RE: IESI – Bethlehem Landfill
Response to EAP Letter Dated 9/27/16
Our file: b/1162.3/2016/EAP/RL92716

We are in receipt of your September 27, 2016 2nd EAP review letter and are providing responses as follows. We have included the DEP comments in conventional font, with our responses in **bold text**.

Southeastern Realignment - Cap Removal & Waste Relocation Plan and Procedures

Attachment 2

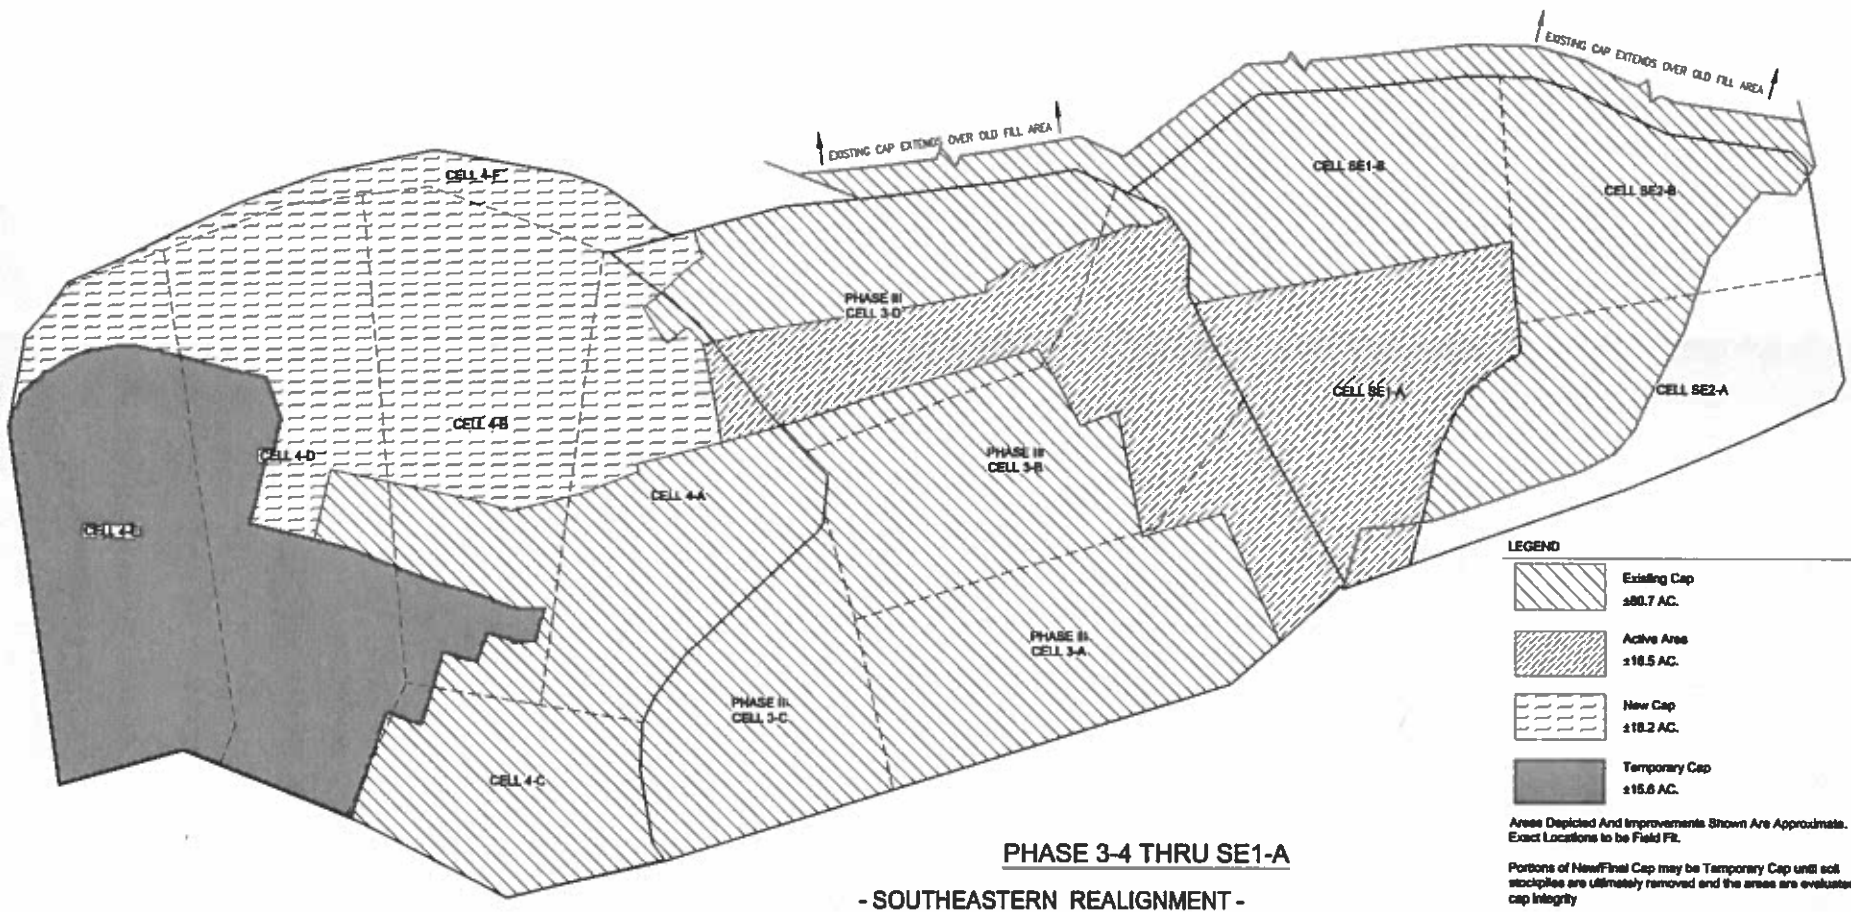
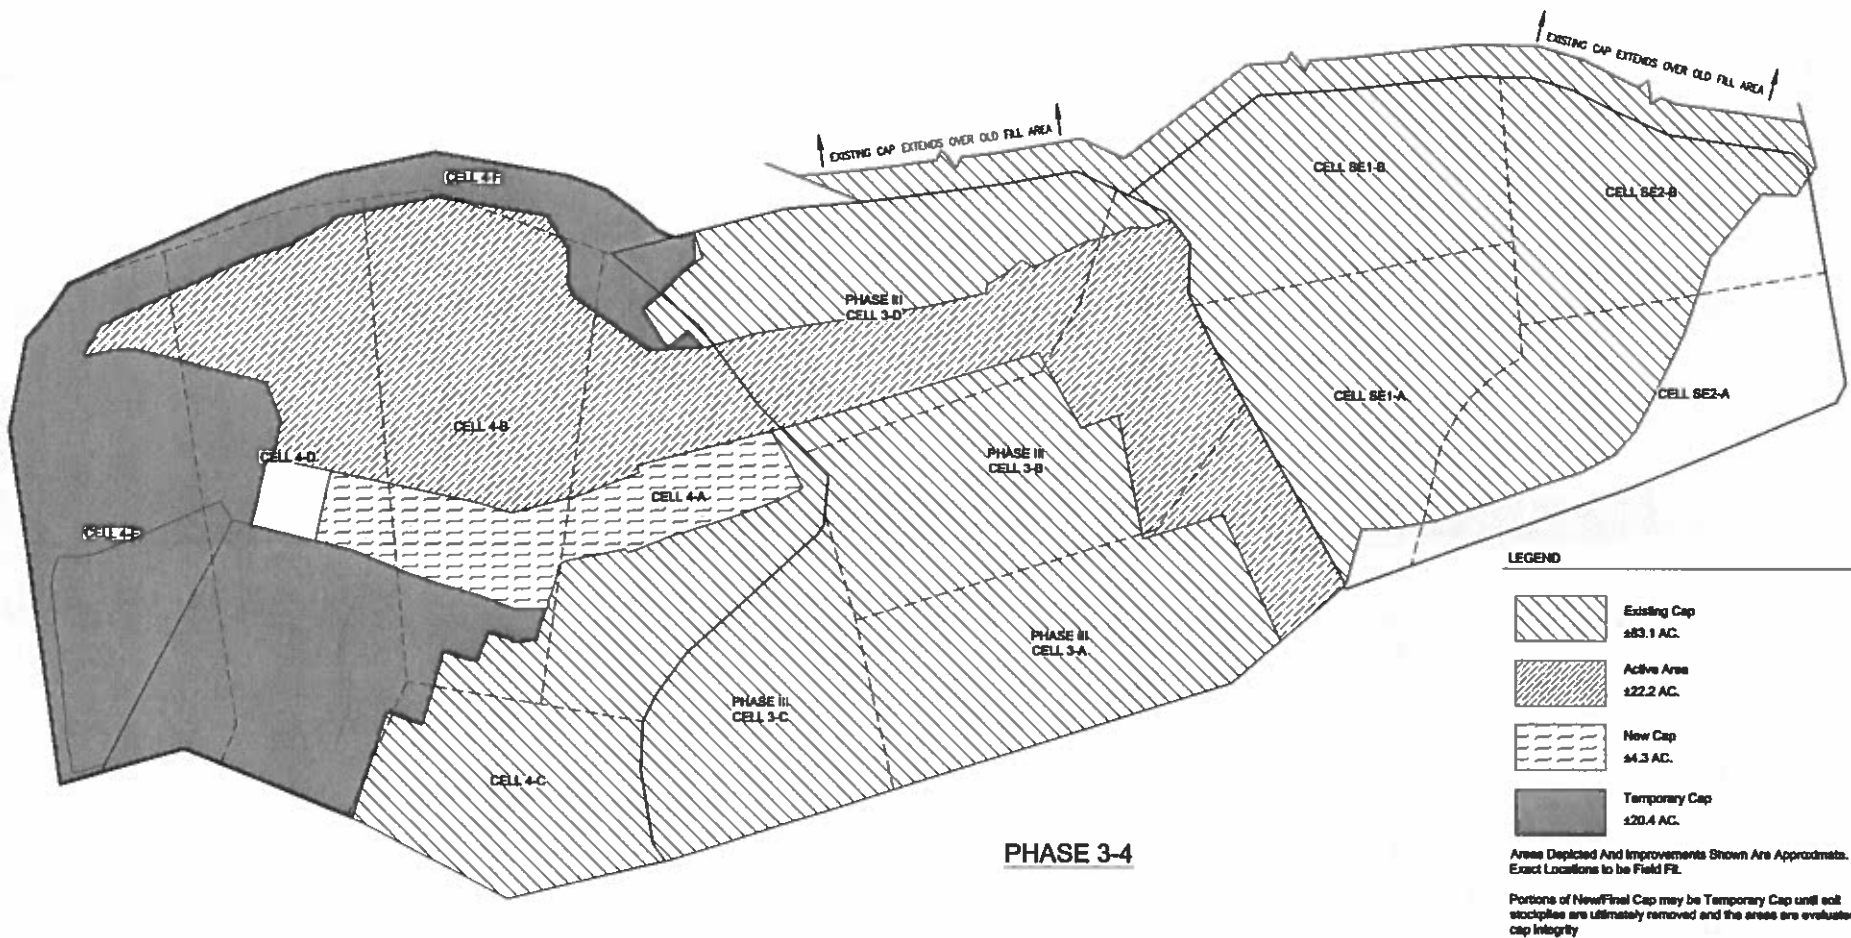
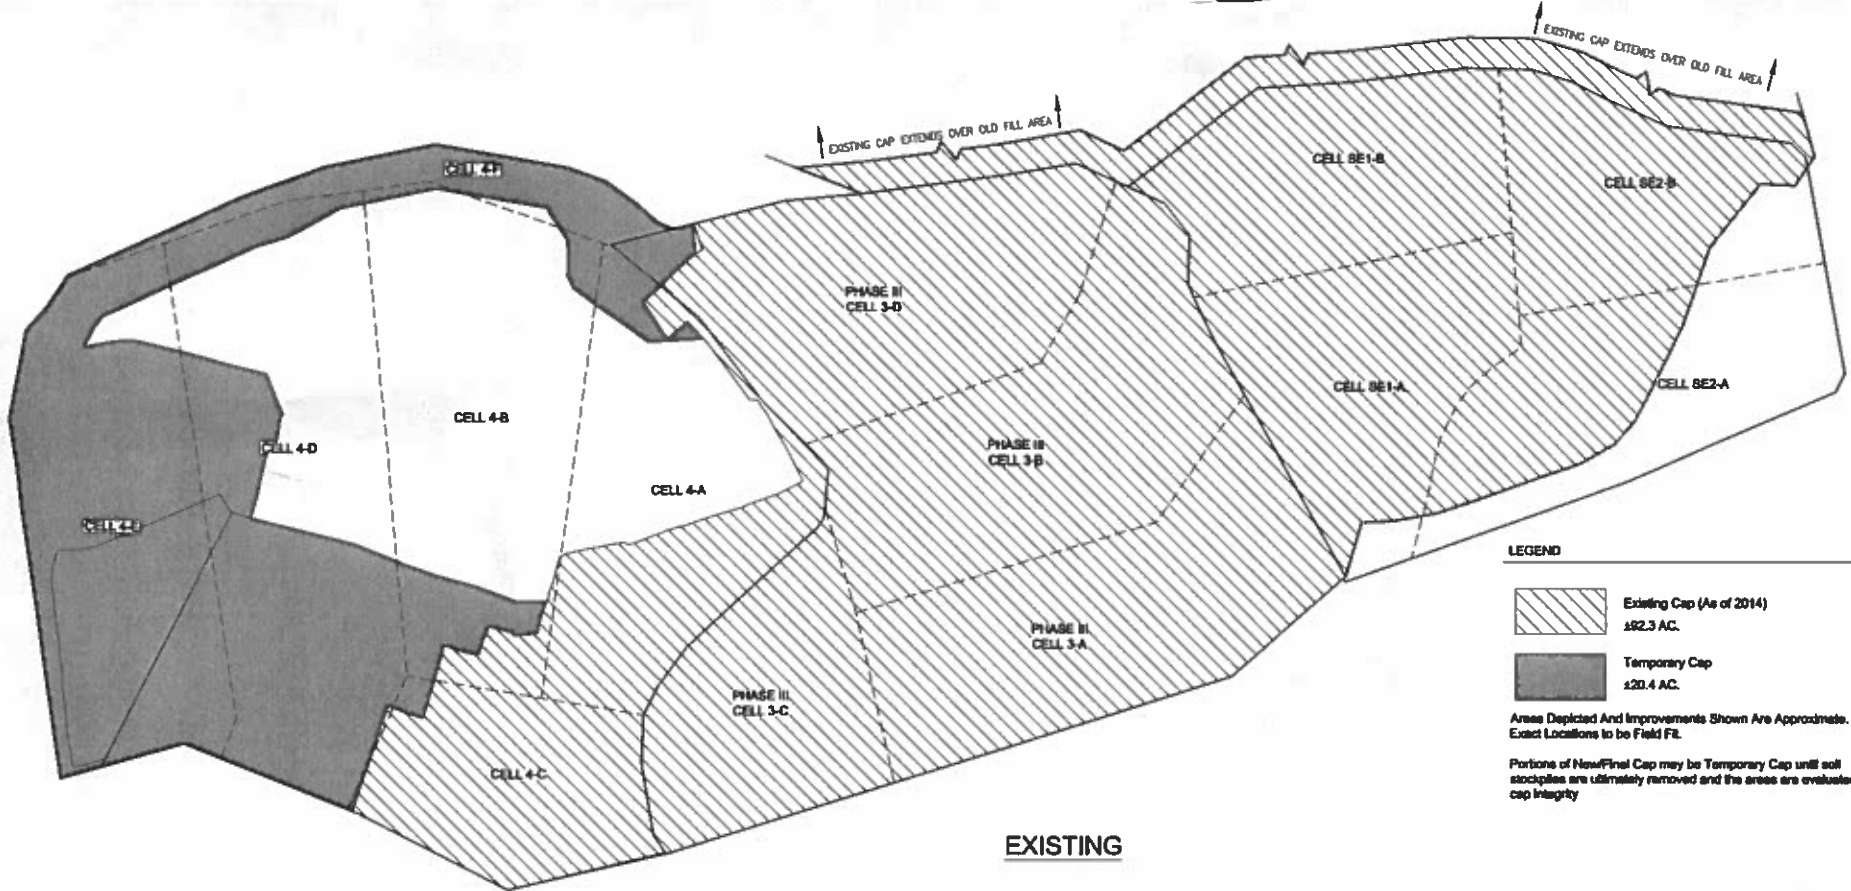
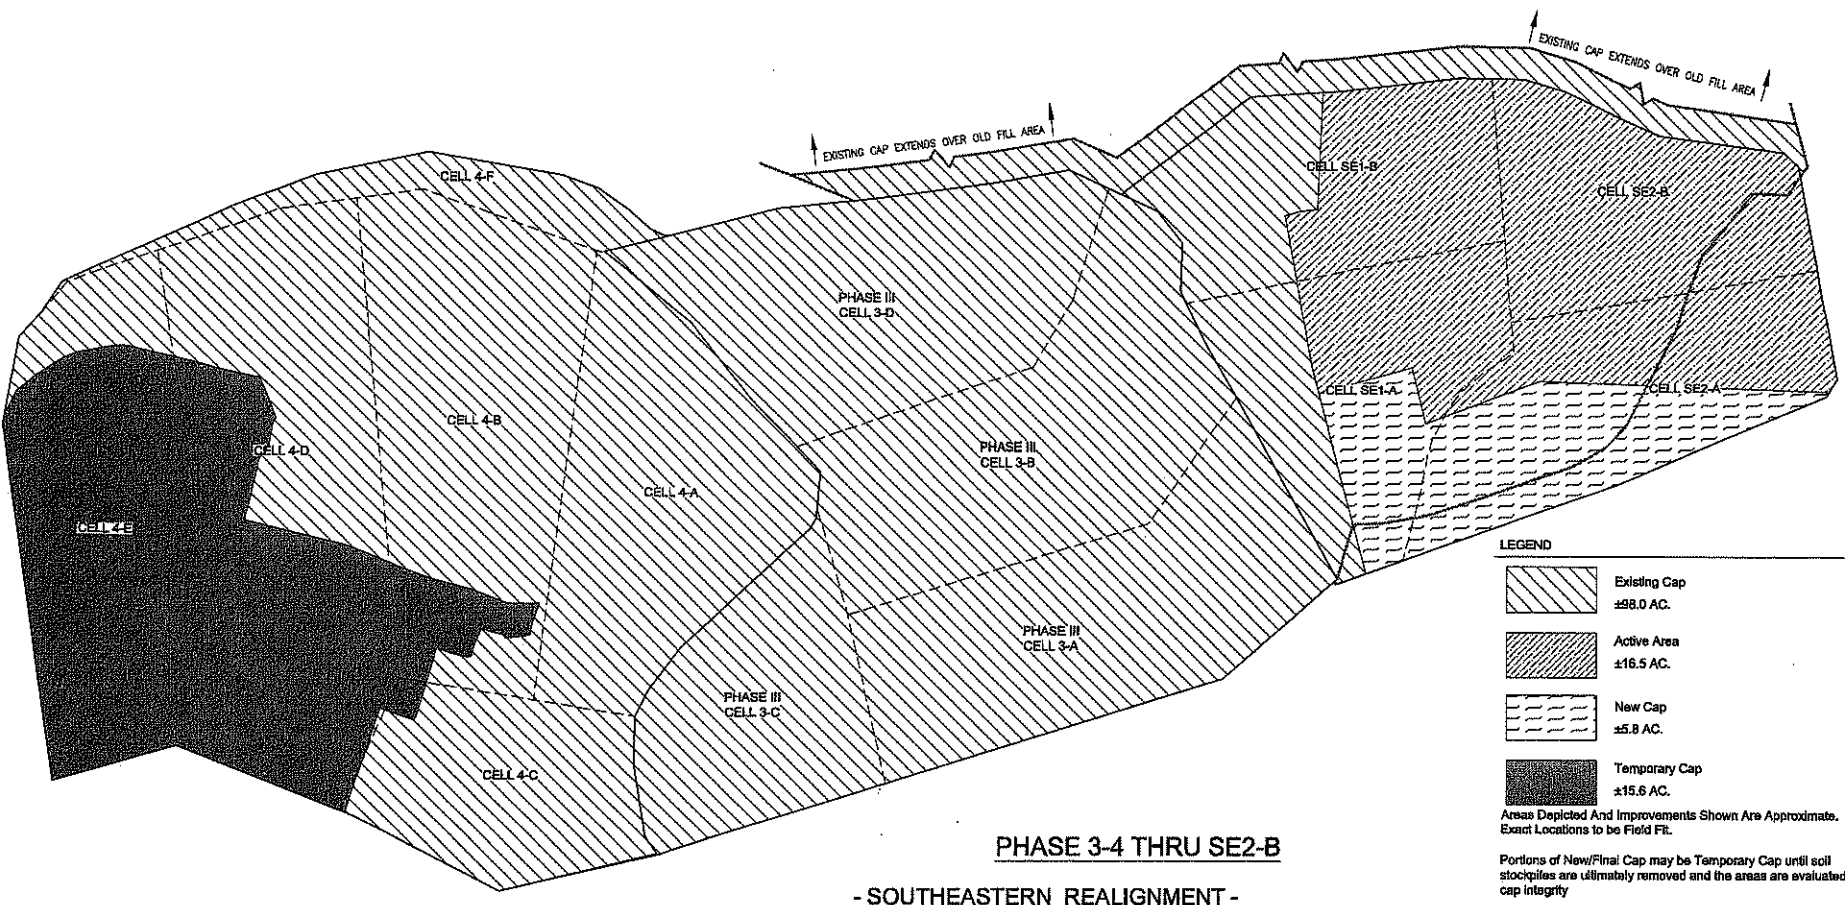
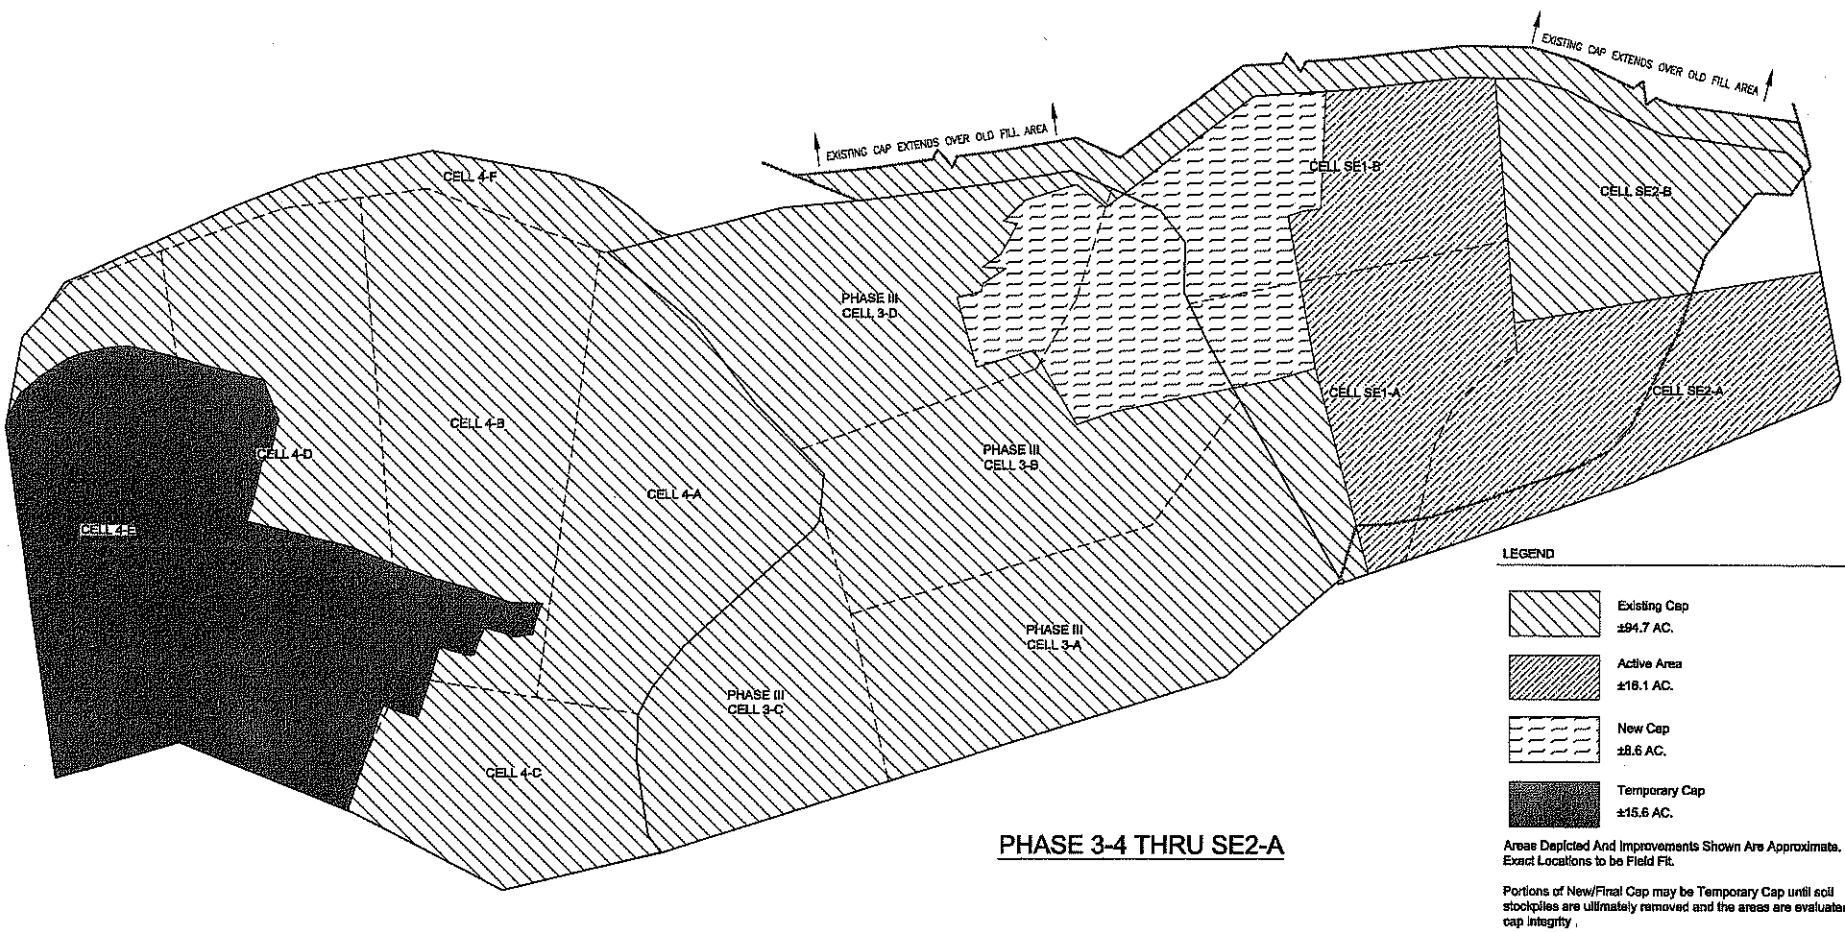
The application should be revised to include more detailed information on the sequencing of the cap removal, gas system removal and construction within Cells SE1-A, SE1-B, SE2-A and SE2-B.

DEP review: The Southeastern Realignment application should be a standalone document and should not reference details included in past applications. In addition, the July 17, 2013 permit modification is only for removal of cap in a ½ acre area. This proposal is for removal of 26 acres. IESI should provide detailed information as to the sequencing of cap removal, gas system removal and construction within Cells CE1-A, SE1-B, SE2-A, AND SE2-B.

therewith as a part of the approved Land Development Permit. Additionally, LF-26 to LF-28 of the Landfill design plans, included here as Attachment 2, show the sequencing of areas where active filling will take place as the various phases of construction/operation evolve. Where there is existing cap within those areas, it will be removed per the Cap Removal Plan (Attachment 1). Per that Plan the ..."area will be limited to that which can be managed within a day or two."
